ADDENDUM NO. 1

Date November 9, 2023
Eugene School District 4J
Gilham Elementary School Roof Replacement 2024

Gilham Elementary School Roof Replacement 2024

Sheet Title:
SECTOR A - ROOF PLAN

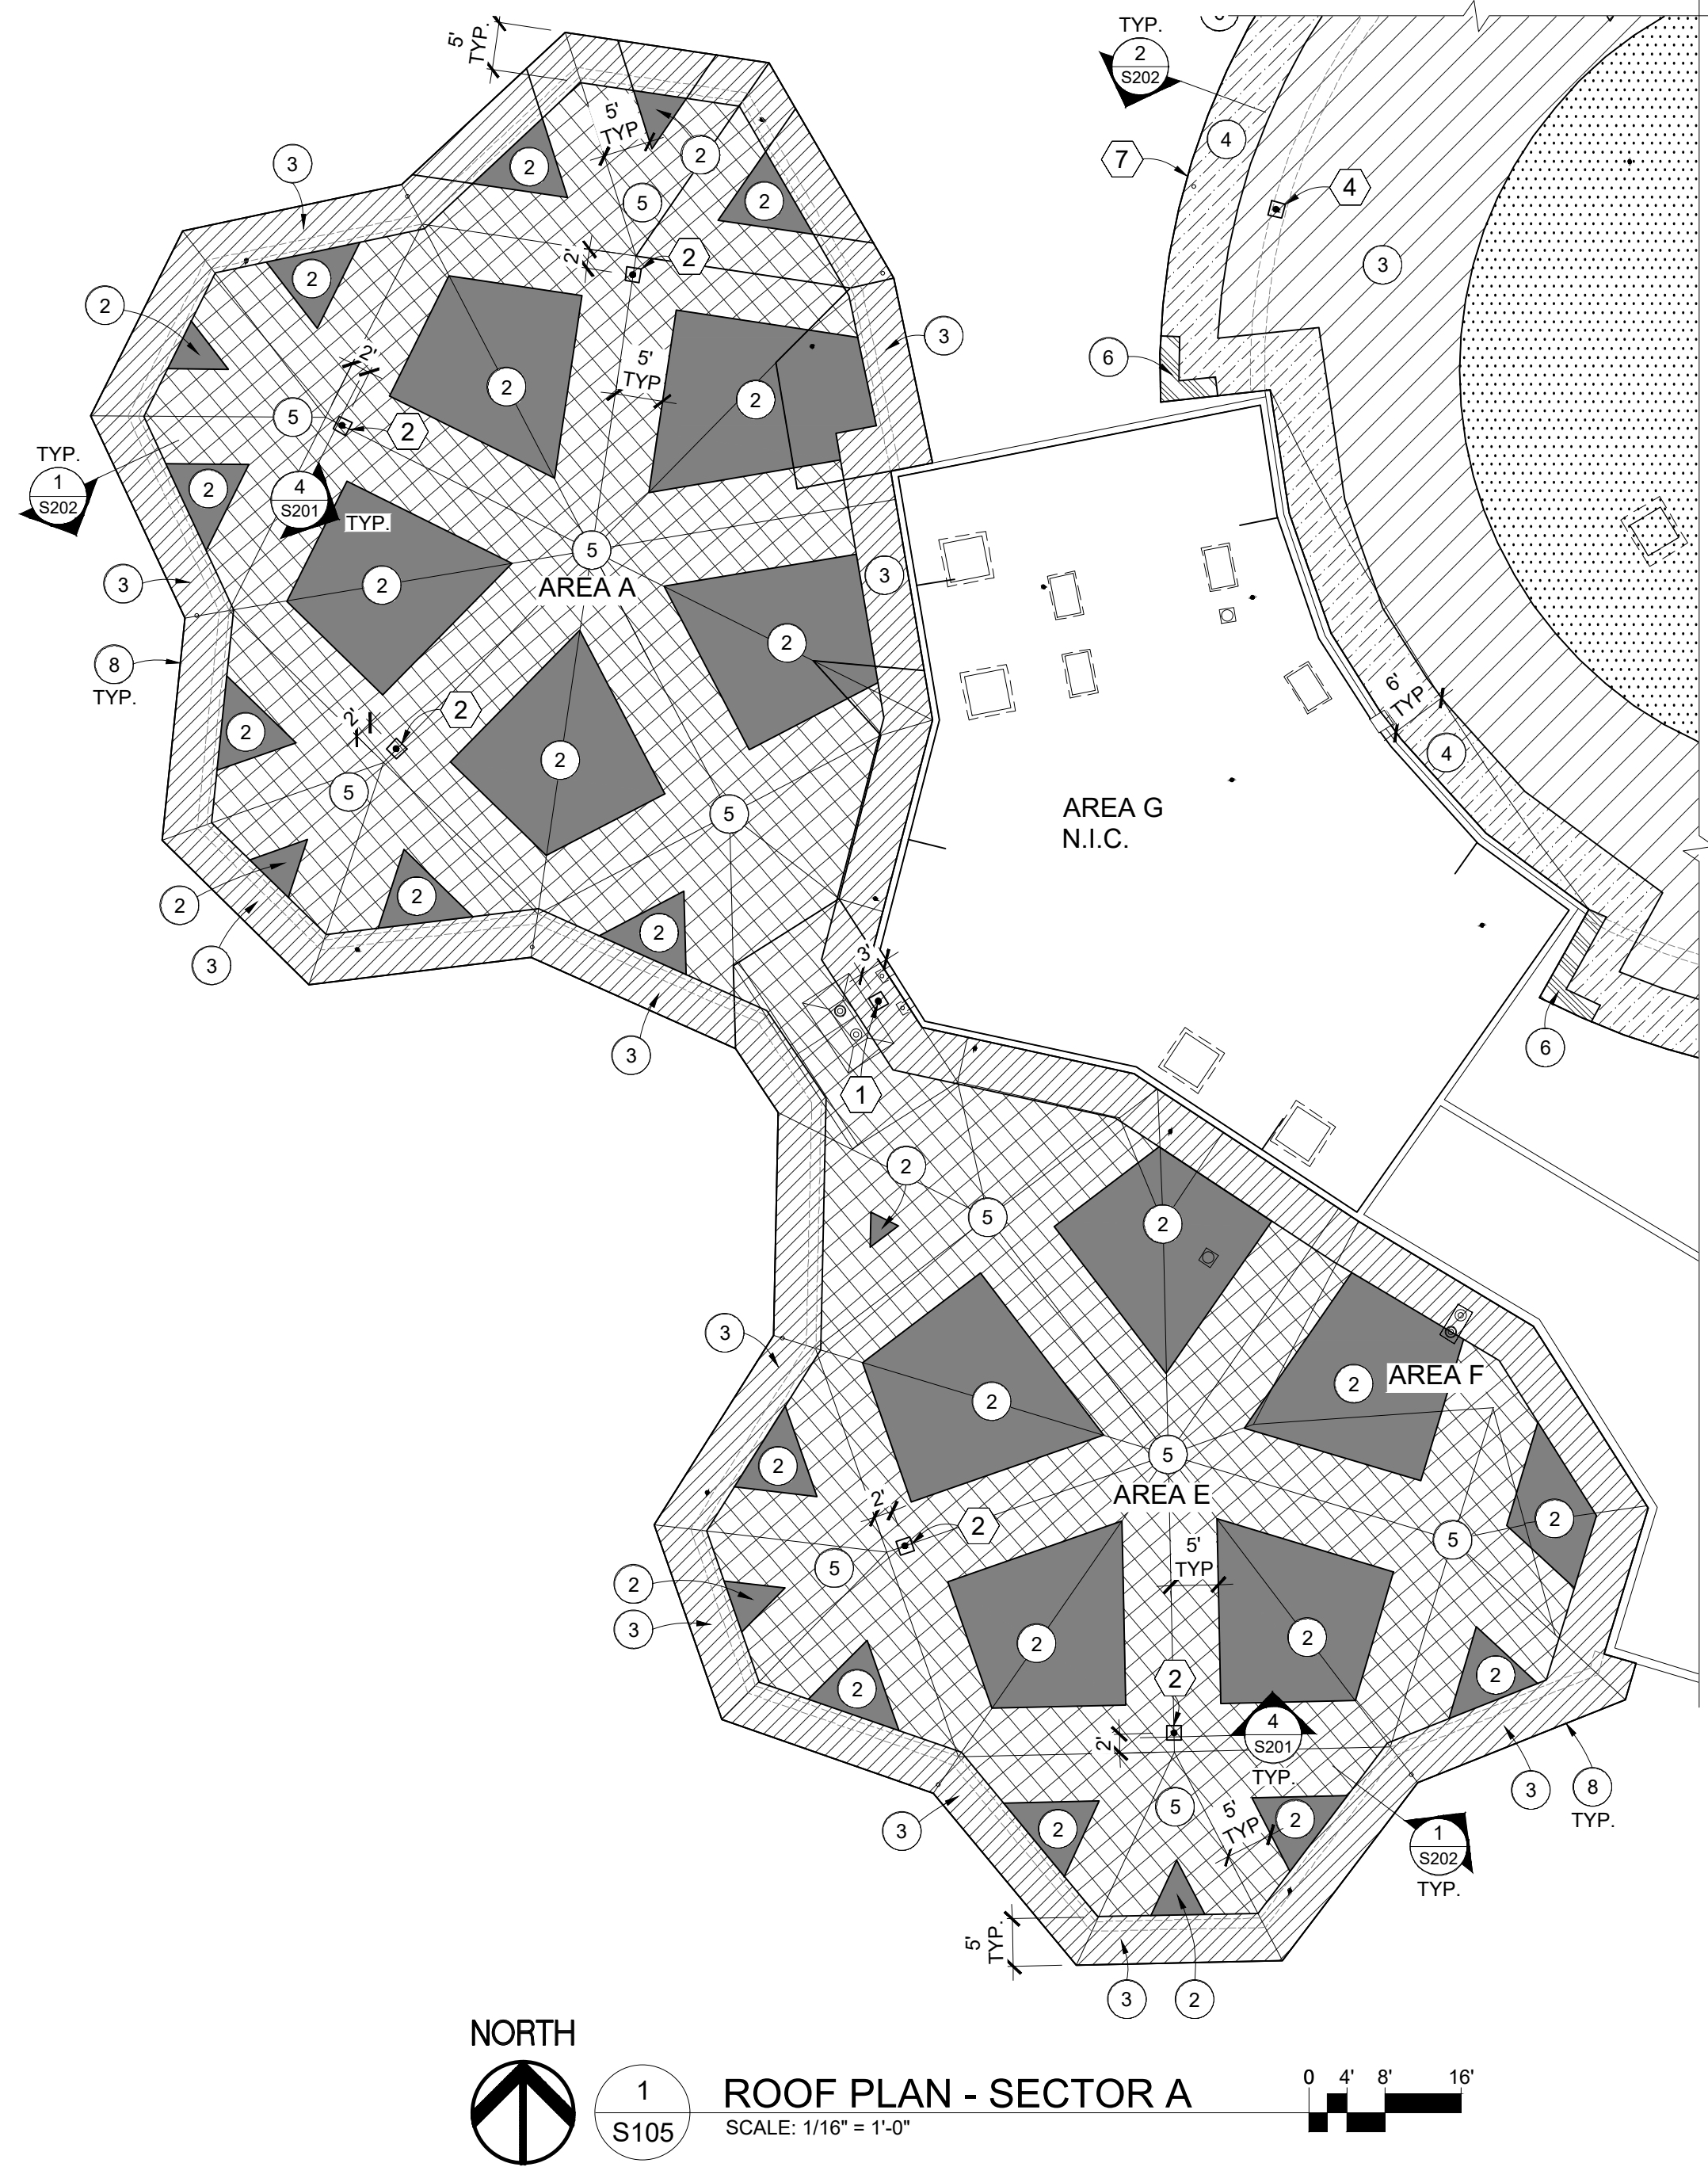
1.08	<i>Drawing Sheet S105</i>	Replace sheet with attached revised Sheet S105. Note the following changes: <ul style="list-style-type: none">• Added Addendum No. 1 revision identifier.• Quantified the number of beam repairs associated with key note #7. There are eight (8) locations total for the project.

1 ROOF PLAN - SECTOR B

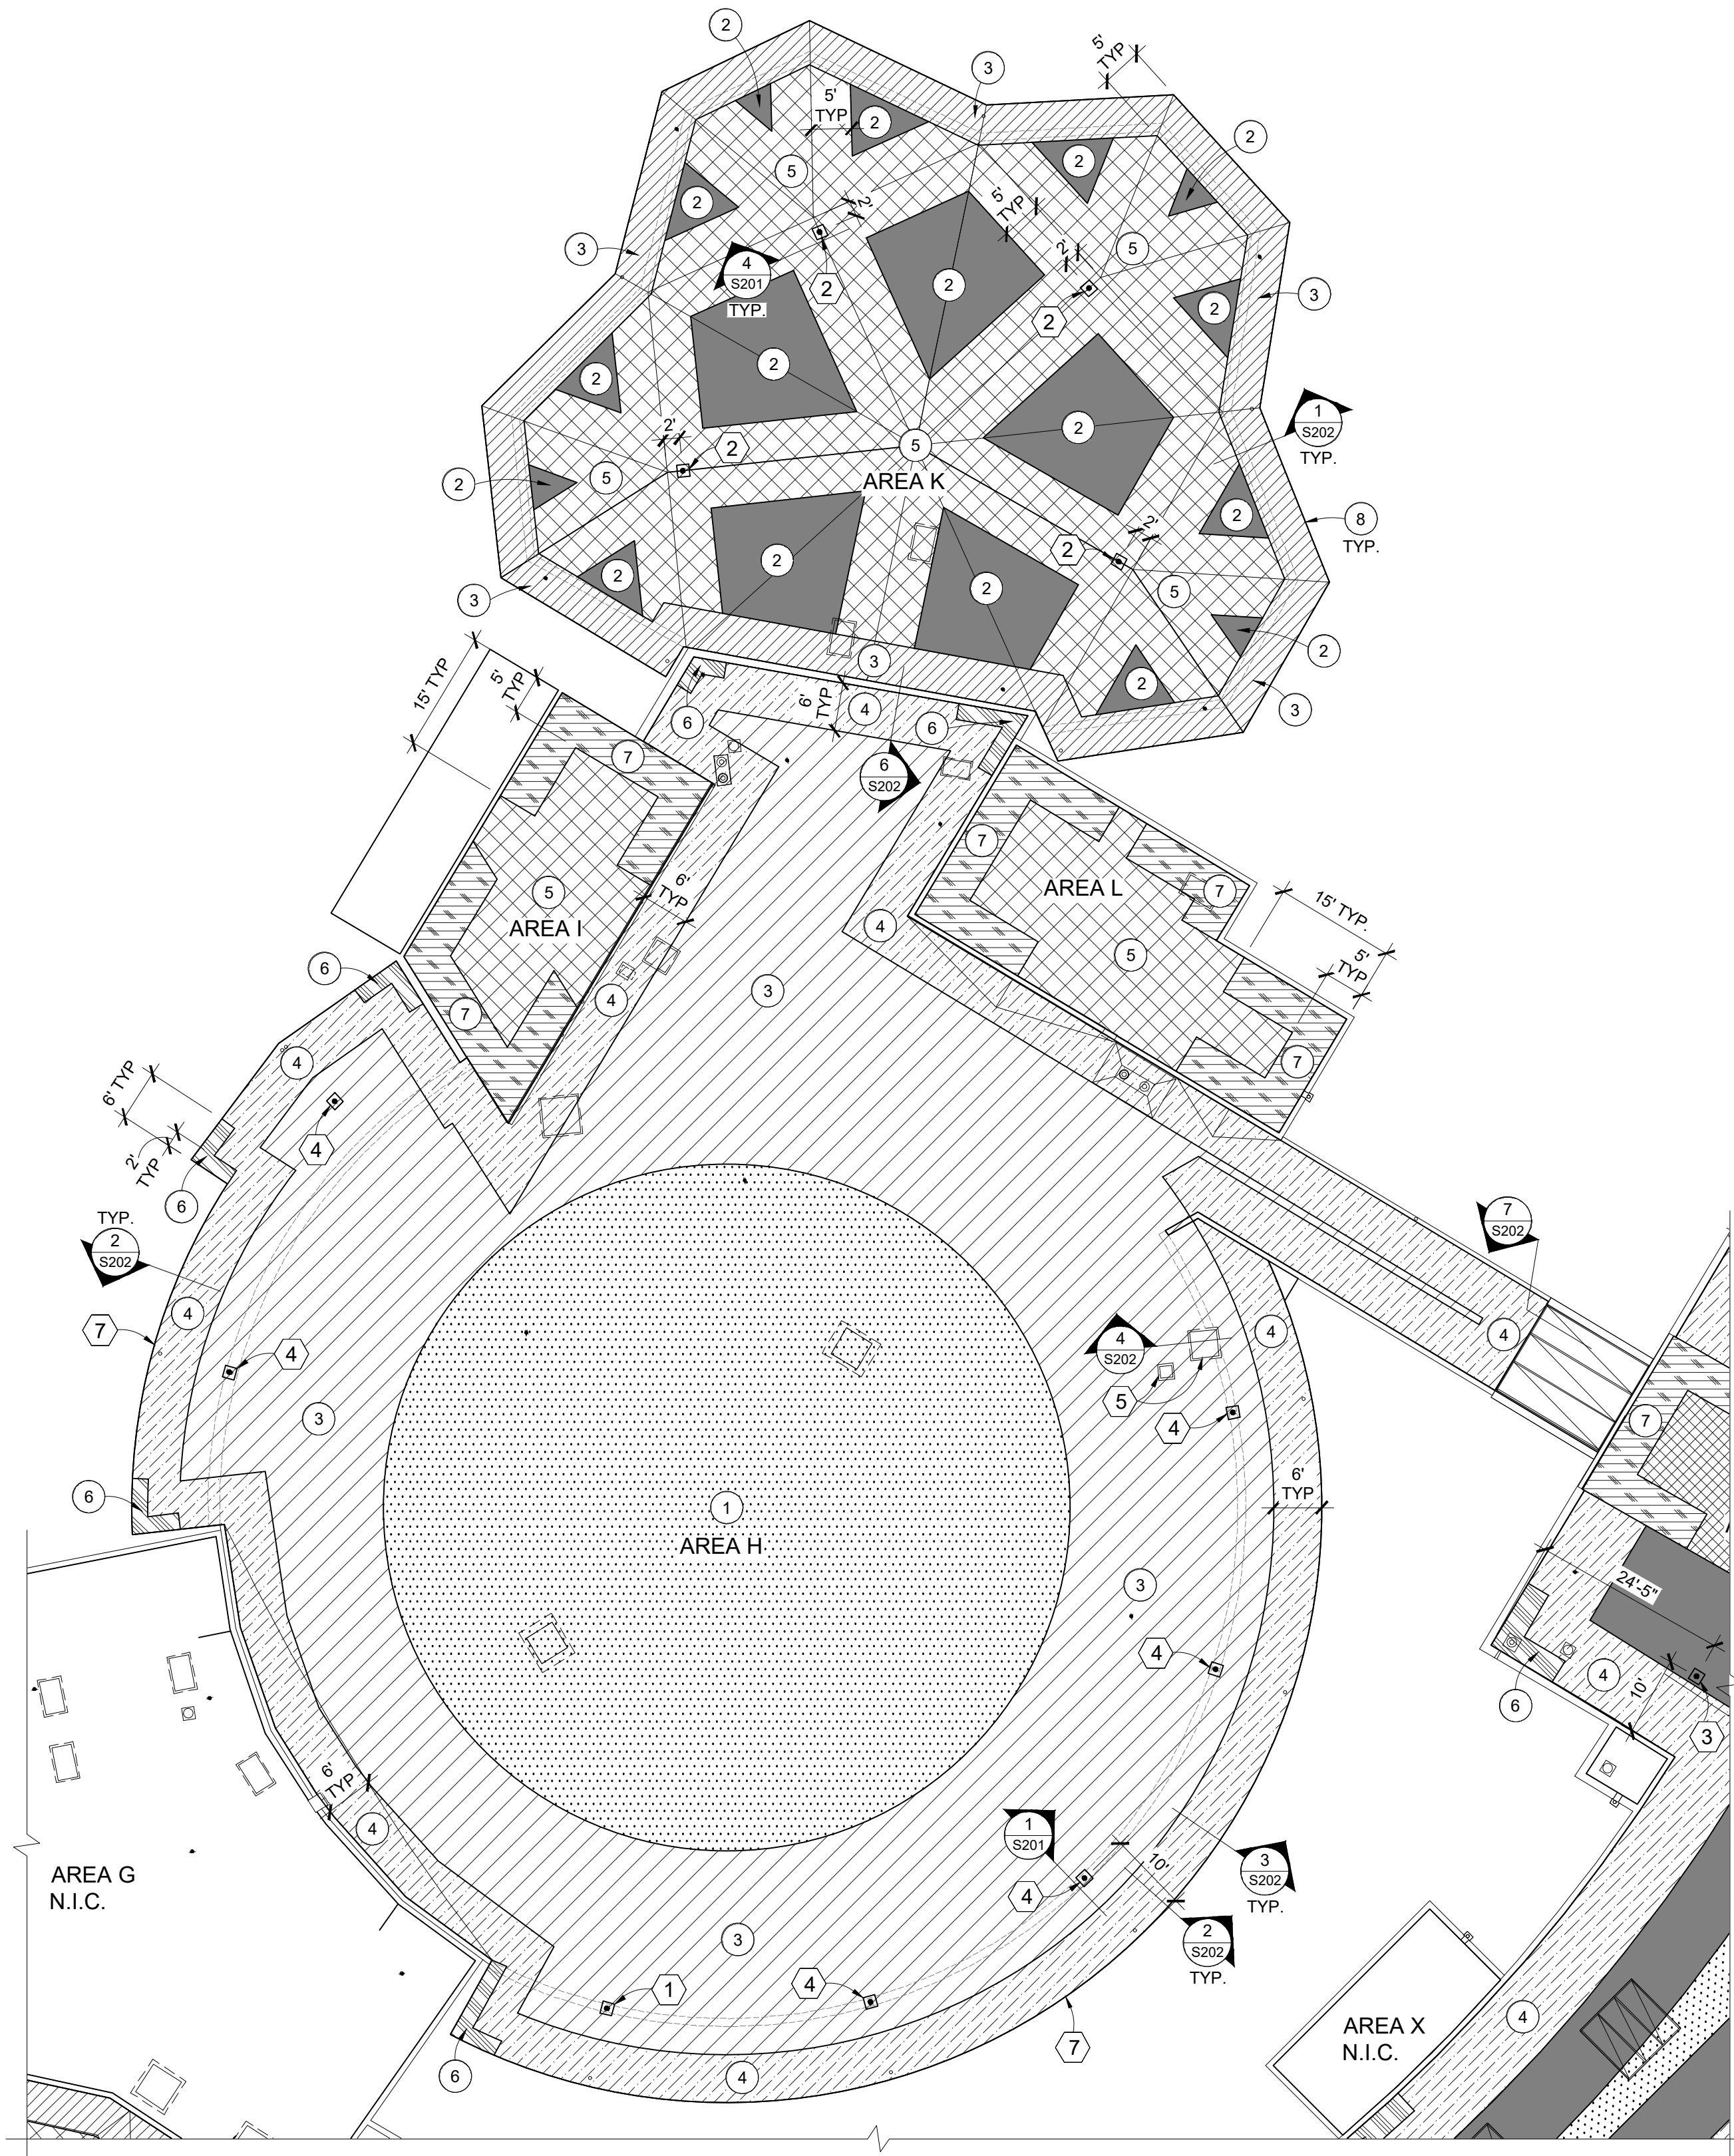
1.09	<i>Drawing Sheet S106</i>	Replace sheet with attached revised Sheet S106. Note the following changes: <ul style="list-style-type: none">• Added Addendum No. 1 revision identifier.• Quantified the number of beam repairs associated with key note #7. There are eight (8) locations total for the project.

ROOF PLAN - SECTOR C

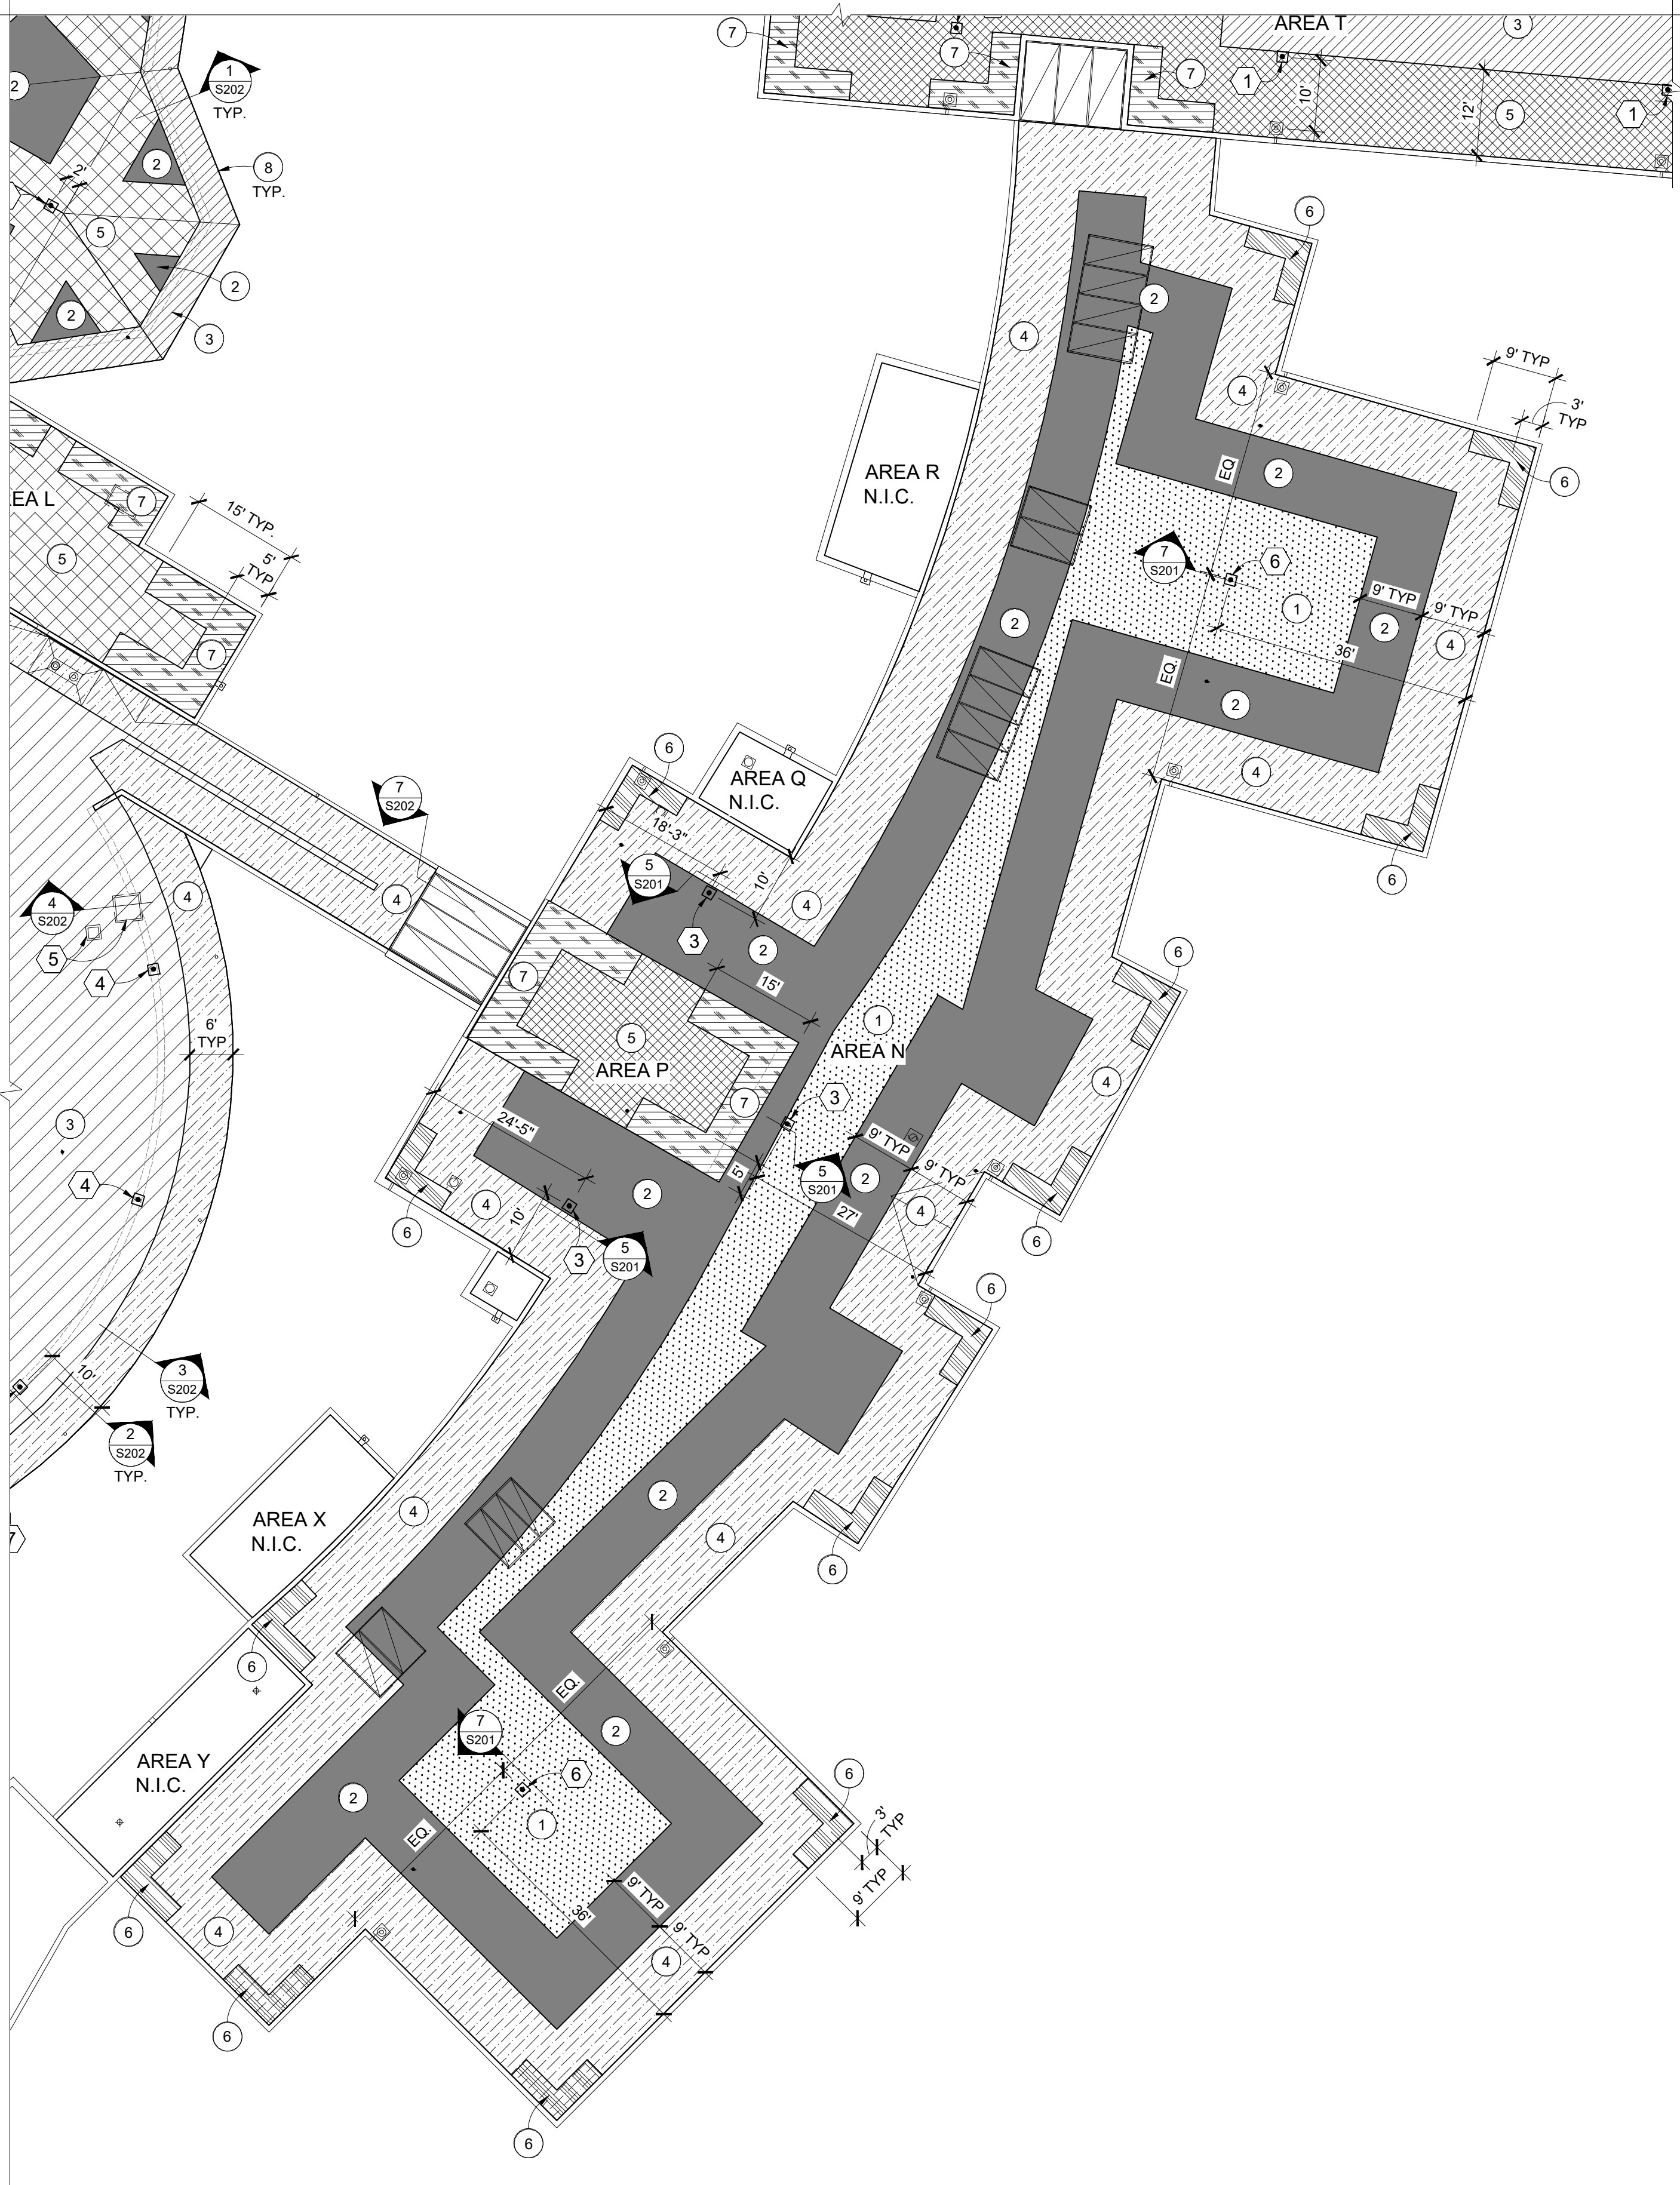
1.10	<i>Drawing Sheet S107</i>	Replace sheet with attached revised Sheet S107. Note the following changes: <ul style="list-style-type: none">• Added Addendum No. 1 revision identifier.• Quantified the number of beam repairs associated with key note #7. There are eight (8) locations total for the project.
